Access Compliance Report

Public Rights-of-Way

(Curb Ramps)

Intersection ID: 30017	Main Street: GREENBANK_CT	Cross Street: OLD_CAROLINA_DR	Location: S
ADA ID: ABC5AAFA270F	Ramp Type: PerpDiag	Initial Pass/Fail: Fail	Overall Compliance: No
Severity Score: 25			
Codes/Mitigation Info/Possible Solution		Field Measurements/Component Compliance

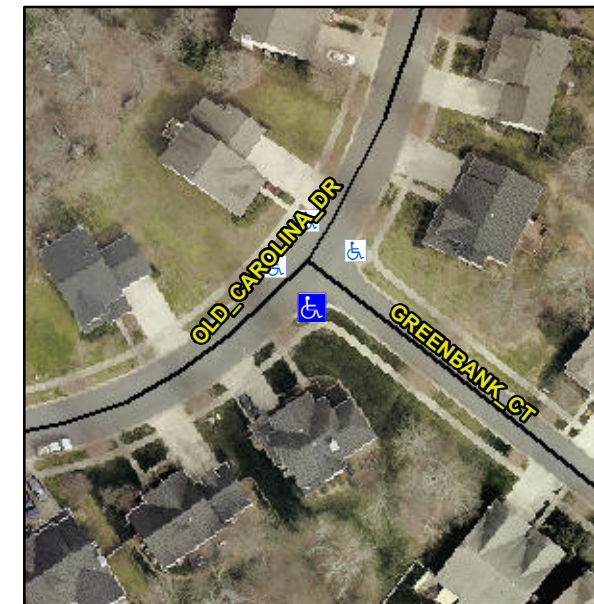
Not Found, R304.5.1, R304.5.3, R302.7

Compliance	Description	Data	Compliance	Description	Data
N/A	Ramp Length (in)	83.0	Yes	Ramp Slope (%)	6.2
No	Ramp Width (in)	42.5	No	Ramp XSlope (%)	2.7
N/A	Flare Type LT	N/A	N/A	Flare Type RT	N/A
N/A	Flare Slope LT (%)	N/A	N/A	Flare Slope RT (%)	N/A
N/A	Flare Traversable LT?	N/A	N/A	Flare Traversable RT?	N/A
N/A	Landing Length (in)	N/A	N/A	DWS Provided?	N/A
N/A	Landing Width (in)	N/A	N/A	DWS Contrast?	N/A
N/A	Landing Slope (%)	N/A	N/A	DWS Length (in)	N/A
N/A	Landing X Slope (%)	N/A	N/A	DWS Full Width?	N/A
N/A	Landing Curb? (Y/N)	N/A	N/A	DWS Offset (in)	N/A
N/A	Shared Landing?	N/A			
N/A	Gutter Ponding?	N/A	N/A	Gutter Slope (%)	N/A
N/A	Gutter Lip Ht (in)	2.0	N/A	Gutter X Slope (%)	N/A
N/A	Painted X Walk1?	No	N/A	Painted X Walk2?	No
	X Walk 1 Direction	To NE		X Walk 2 Direction	To NW
N/A	X Walk 1 Width (in)	N/A	N/A	X Walk 2 Width (in)	N/A
	X Walk 1 Slope (%)	3.7		X Walk 2 Slope (%)	5.1
	X Walk 1 X Slope (%)	4.5		X Walk 2 X Slope (%)	1.3

N/A	Ramp inside XWalk1?	N/A	N/A	Ramp inside XWalk2?	N/A
	Road Slope (%)	3.9	N/A	Clear Space?	N/A
	Road X Slope (%)	6.1	N/A	Clear Space to XWalk (in)	N/A
N/A	Any Obstructions?	N/A	N/A	Storm Grate/Utility Hazard?	N/A
	Obstruction Type			Storm Grate/Utility Type	
		N/A			N/A
		No		Surface Condition? (G/P)	Poor

Remove & Replace Curb Ramp With Two New Directional Ramps or Equivalent.
